Addendum 3
Solicitation 22-99418
City Hall MEP Renewal Project

This addendum serves to notify all bidders of the following changes to the solicitation documents:

1 A220 REFLECTED CEILING PLAN–GROUND FLOOR

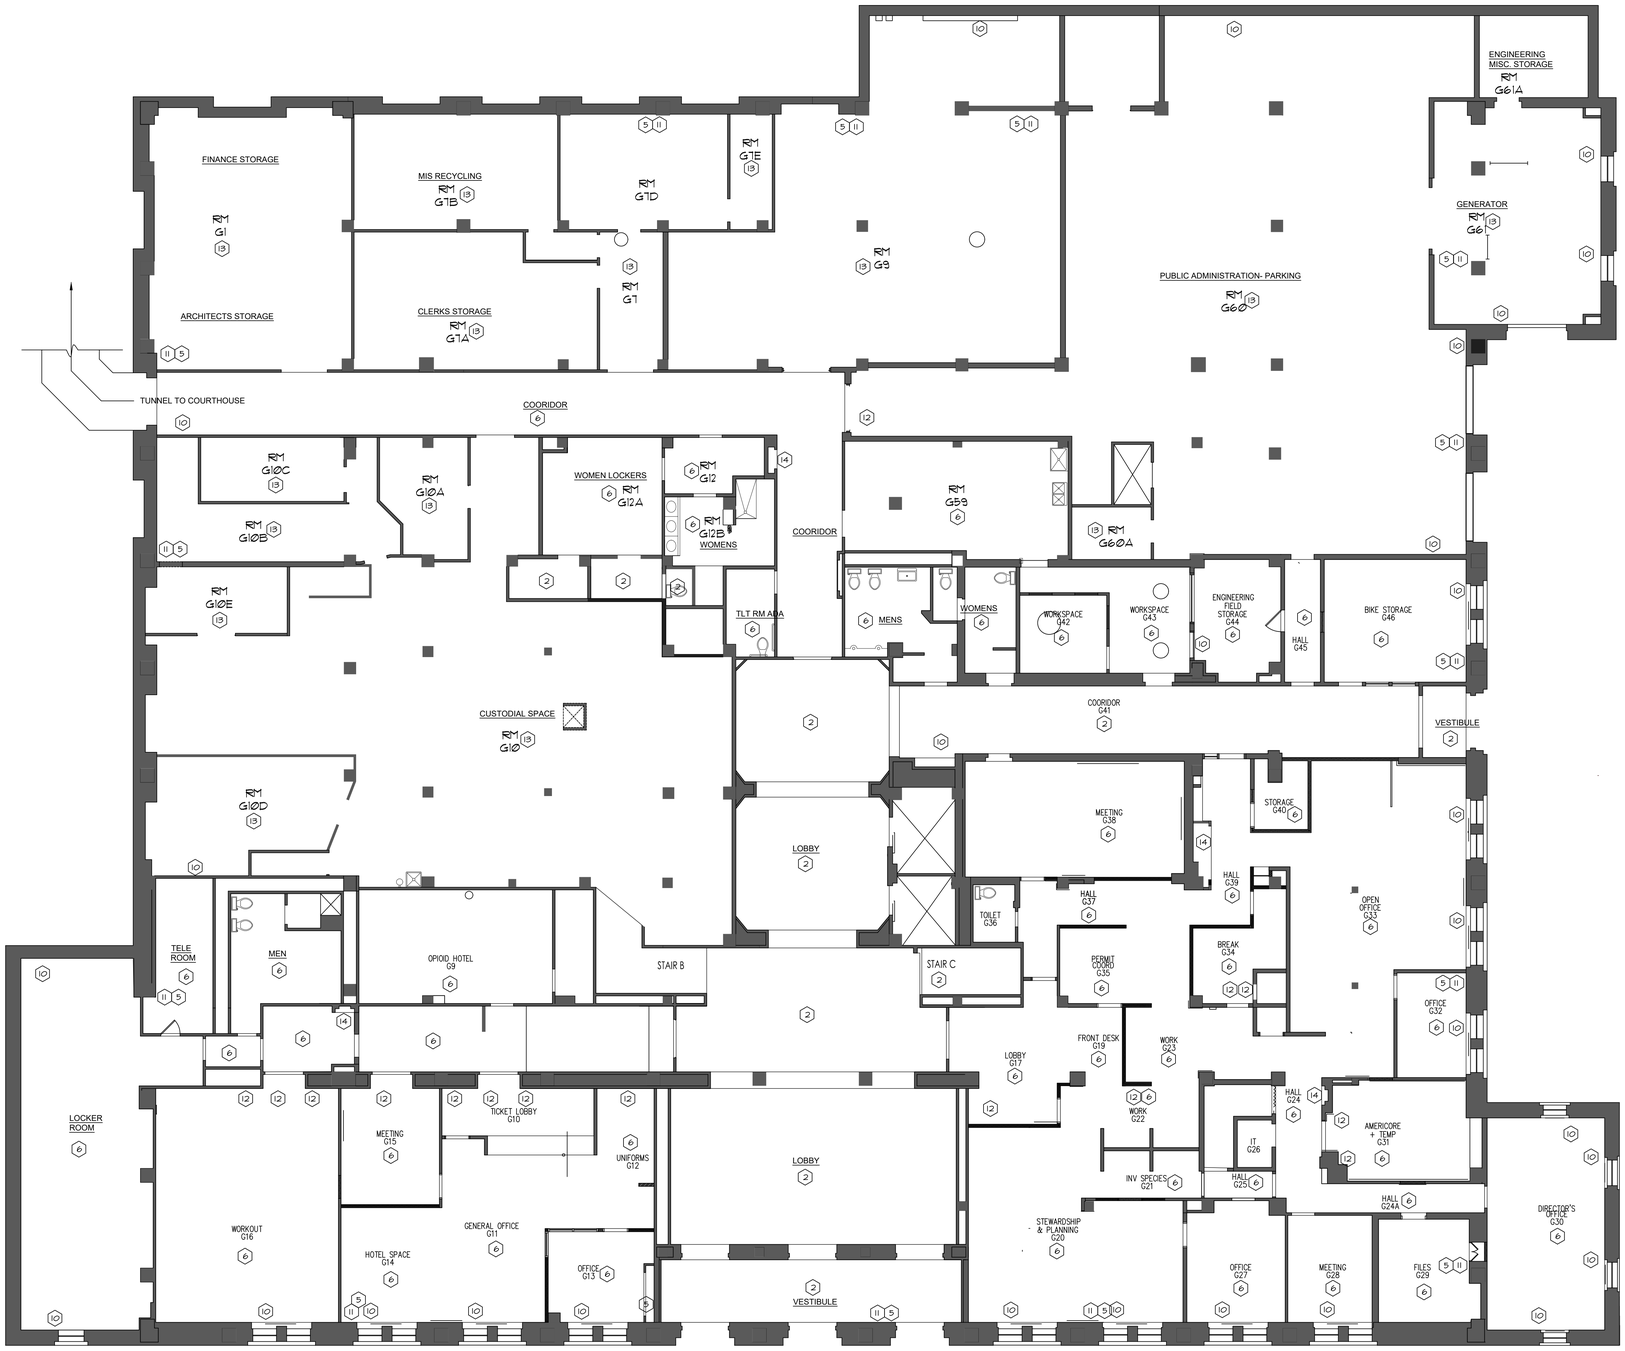
1.) Sheets A220, A230, A240, A250 AND A260:
a. General Note #4 is revised.
THESE DRAWINS DO NOT DETAIL EVERY INSTANCE WHERE CUTTING AND PATCHING NEEDS TO OCCUR. COORDINAE ALL CUTTING AND PATCHING WORK WITH MECHANICAL CONTRACTOR AND FIELD VERIFY ALL EXISTING CONDITIONS. EXISTING CONSTRUCITON SCHEDULE TO REMAIN THAT IS DAMAGEDD AS A RESUL OF THE WORK SHALL BE REAPRED TO AN EXTENT AND AS REQUIRED TO MATCH ADJACENT EXISTING UNDAMAGED CONSTRUCTION.
